WELL API NO. 30-039-27803
5. Indicate Type of Lease STATE <input type="checkbox"/> FEE <input type="checkbox"/>
6. State Oil & Gas Lease No.
7. Lease Name or Unit Agreement Name RINCON UNIT
8. Well Number #412
9. OGRID Number 189071
10. Pool name or Wildcat BASIN DAKOTA/BLANCO MESAVERDE
11. Elevation (Show whether DR, RKB, RT, GR, etc.)

NOTICE OF INTENTION TO:		SUBSEQUENT REPORT OF:	
PERFORM REMEDIAL WORK <input type="checkbox"/>	PLUG AND ABANDON <input type="checkbox"/>	REMEDIAL WORK <input type="checkbox"/>	ALTERING CASING <input type="checkbox"/>
TEMPORARILY ABANDON <input type="checkbox"/>	CHANGE PLANS <input checked="" type="checkbox"/>	COMMENCE DRILLING OPNS. <input type="checkbox"/>	P AND A <input type="checkbox"/>
PULL OR ALTER CASING <input type="checkbox"/>	MULTIPLE COMPL <input type="checkbox"/>	CASING/CEMENT JOB <input type="checkbox"/>	
OTHER: CHANGE OF PLANNED FACILITIES <input checked="" type="checkbox"/>		OTHER: <input type="checkbox"/>

TC-STANDARD FACILITY

SITE PLAN

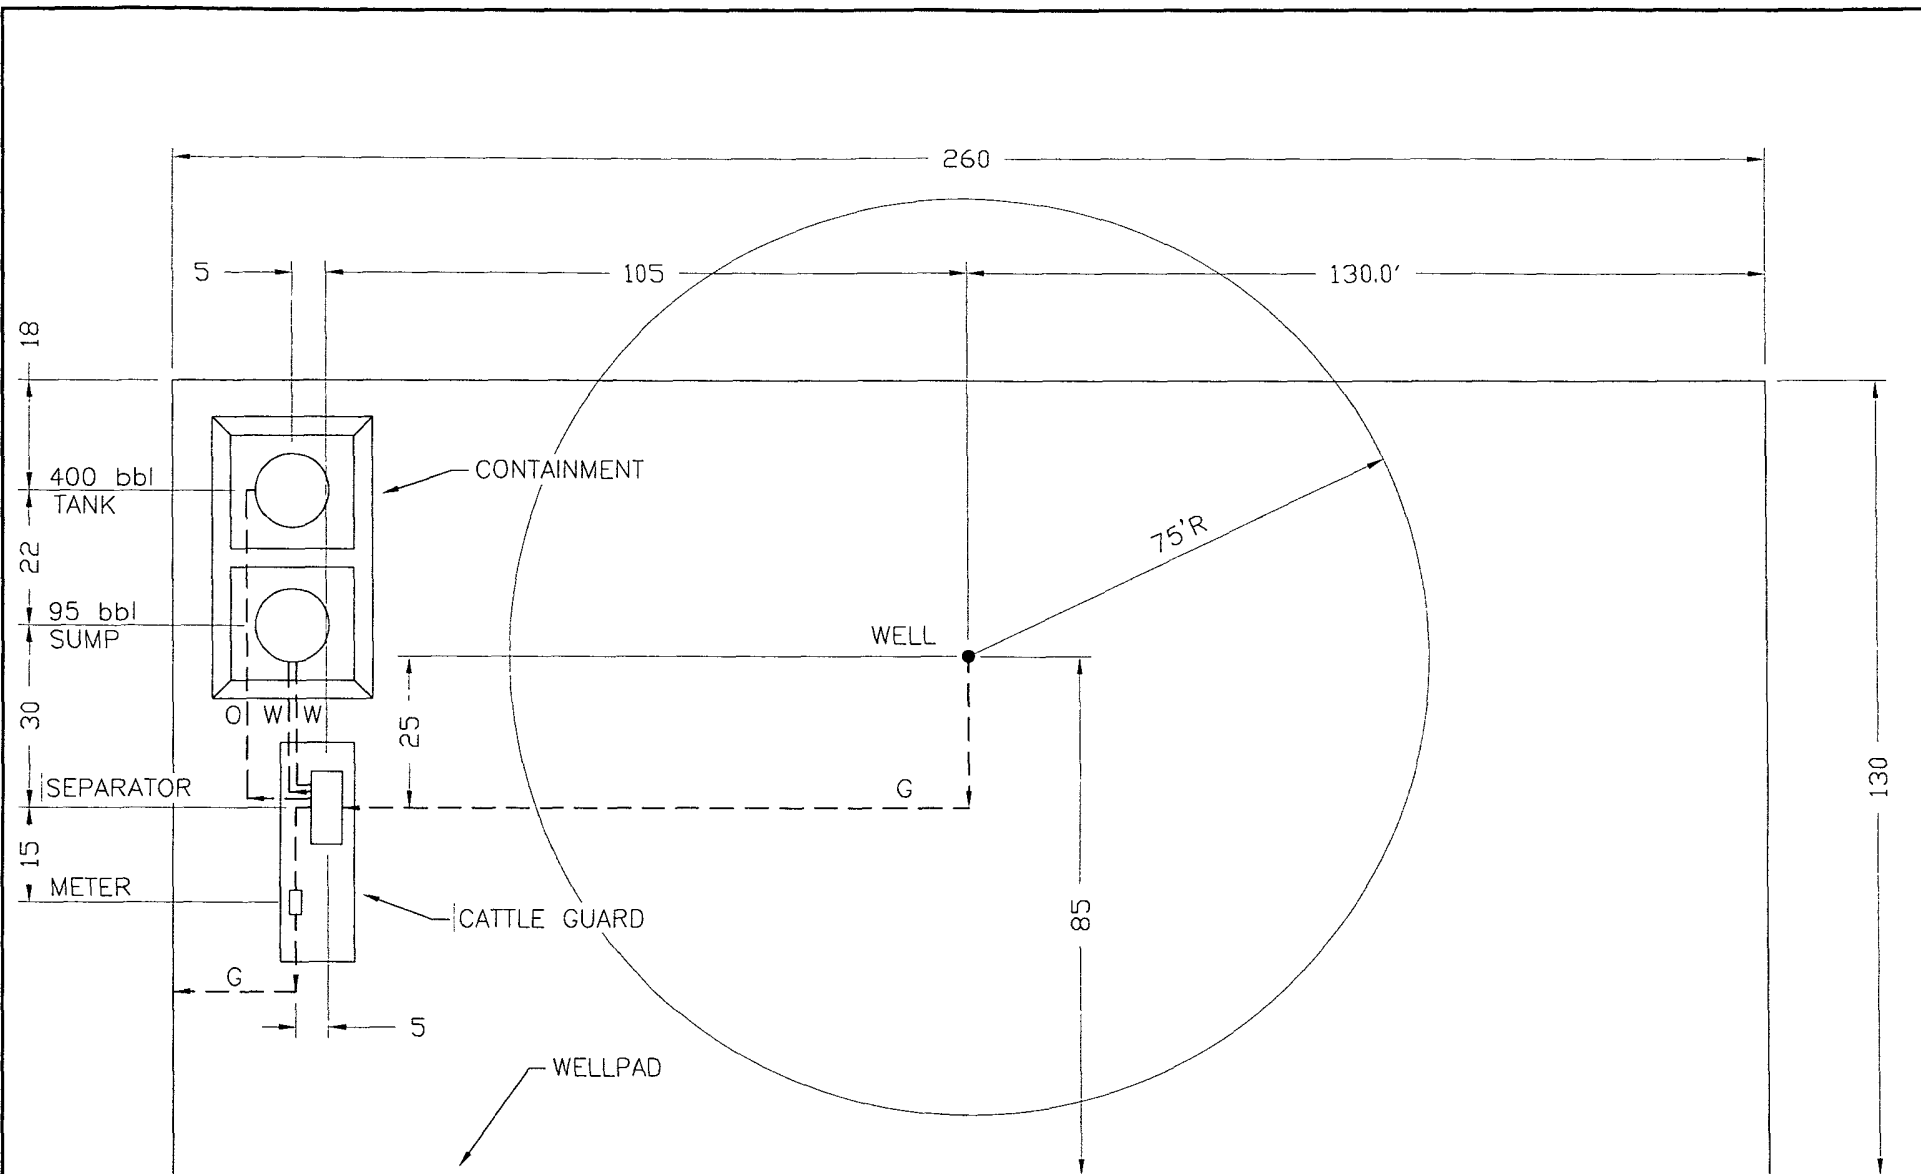
Chevron MidContinent, L.P. reports that we have changed our planned facilities for the above mentioned location. A ~400 BBL steel tank, a ~95 BBL below-grade steel tank, a separator, and an Enterprise meter run will be installed on the well pad. Attached is a basic diagram of how these facilities would be arranged on a wellsite and a basic diagram of the 95Bbl below-grade steel tank. Should you have any questions or require any additional information, please feel free to contact us at anytime.
